# Technical Journal

TITLE:  
**Fender flares, poor fit**

<b>REF NO:</b> TJ 31446	<b>ISSUING DEPARTMENT:</b> Technical Service	<b>CAR MARKET:</b> United States and Canada	
<b>PARTNER:</b> 3 US 7510 Volvo Car USA		<b>ISSUE DATE:</b> 2016-04-19	<b>STATUS DATE:</b> 2016-04-22
<b>FUNC GROUP:</b> 8259	<b>FUNC DESC:</b> Miscellaneous	Page 1 of 3

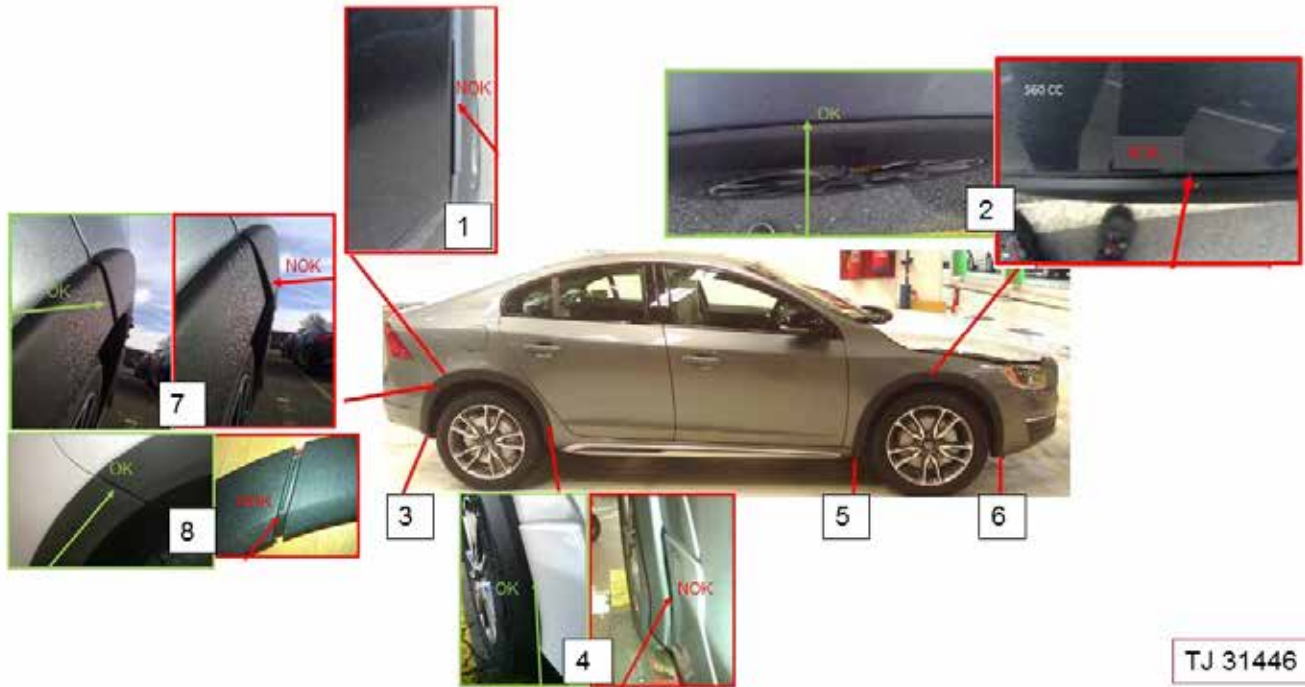
The front and rear fender flares may have poor fit. Improvements have been implemented on parts from structure weeks above.

If a failure occurs after the breakpoint, please report back on which fender flare, and where the location of the failure is. See attached guideline to judge the failure.

Replace the fender flare according to VIDA. If a failure may occur on vehicles after above structure weeks, document the failure mode before the repair is done.

Add relevant information like comments and photos that describe the location of the failure. Take photos from different views.
